SUBJECT: License Amendment Request
To Add Cask Loading Restrictions
Arkansas Nuclear One, Unit 2
Docket No. 50-368
License No. NPF-6

Analysis of Proposed Technical Specification Changes

Proposed Technical Specification Changes (mark-up)

Figure 3.9-1
Loading Restrictions for MPC-32
(Fuel Cooling Time > 3 years)

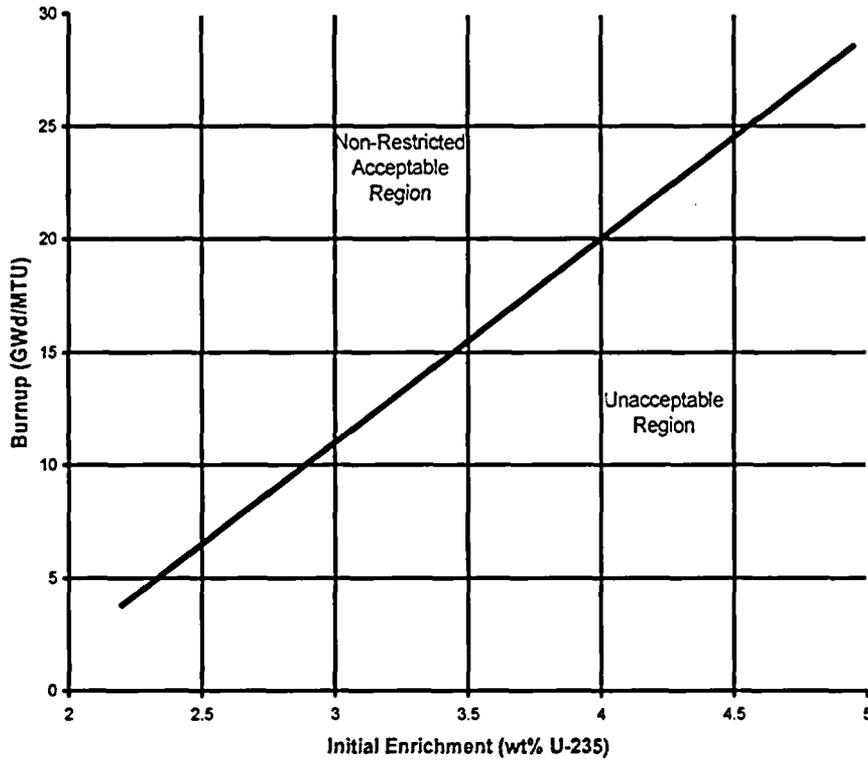
- A new TS Limiting Condition for Operation (LCO) will be added, LCO 3.9.12.d, to identify that there are loading restrictions for the MPC-32 included in TS Figure 3.9-1.
- An additional loading restriction for the MPC-32 will be added as TS Figure 3.9-1.
- A note will be added to the applicability stating that the cask loading pit and tilt pit are considered part of the SFP when their associated gates are open.
- SR 4.9.12.d will be added to verify that fuel assemblies are placed in a storage cask within the limits of Figure 3.9-1 by checking the assemblies' design and burnup documentation.

- 3.9.12.a Storage in the spent fuel pool shall be restricted to fuel assemblies having initial enrichment less than or equal to 4.55 ± 0.05 w/o U-235. The provisions of Specification 3.0.3 are not applicable.
- 3.9.12.b Storage in the spent fuel pool shall be further restricted by the limits specified in Figure 3.9.2. The provisions of Specification 3.0.3 are not applicable.
- 3.9.12.c The boron concentration in the spent fuel pool shall be maintained (at all times) at greater than 2000 parts per million.
- 3.9.12.d Storage in the MPC-32 shall be further restricted by the limits specified in Figure 3.9-1. The provisions of Specification 3.0.3 are not applicable.

- 4.9.12.a Verify all fuel assemblies to be placed in the spent fuel pool have an initial enrichment of less than or equal to 4.55 ± 0.05 w/o U-235 by checking the assemblies' design documentation.
- 4.9.12.b Verify all fuel assemblies to be placed in the spent fuel pool are within the limits of Figure 3.9.2 by checking the assemblies' design and burnup documentation.
- 4.9.12.c Verify at least once per 31 days the spent fuel pool boron concentration is greater than 2000 ppm.
- 4.9.12.d Verify all fuel assemblies to be placed in a storage cask are within the limits of Figure 3.9-1 by checking the assemblies' design and burnup documentation.

$$\begin{aligned} \text{FA BU} &\geq 9E - 16 \text{ (GWD/MTU)} \\ \text{FA CT} &\geq 3 \text{ (years)} \end{aligned}$$

Where FA BU = Fuel assembly burnup
E = Initial average fuel assembly enrichment
FA CT = Fuel assembly cooling time from last at power operations
